1771-SDN Series C DeviceNet Scanner Module Firmware

Cat. No. 1771-SDN/C, Revision 6.007

Purpose

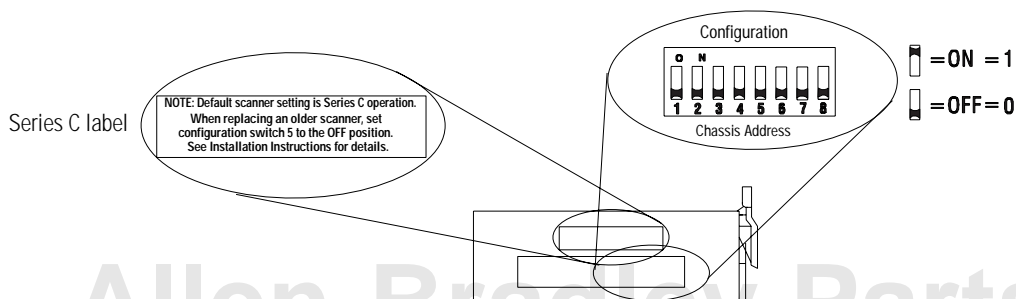
The 1771-SDN/C DeviceNet Scanner Module is fully compatible with the Series A and Series B versions. You can use the Series C version as a spare or replacement module with one requirement: **you must change the position of Switch 5 to the off or “0” position in the Configuration switchbank as shown below:**
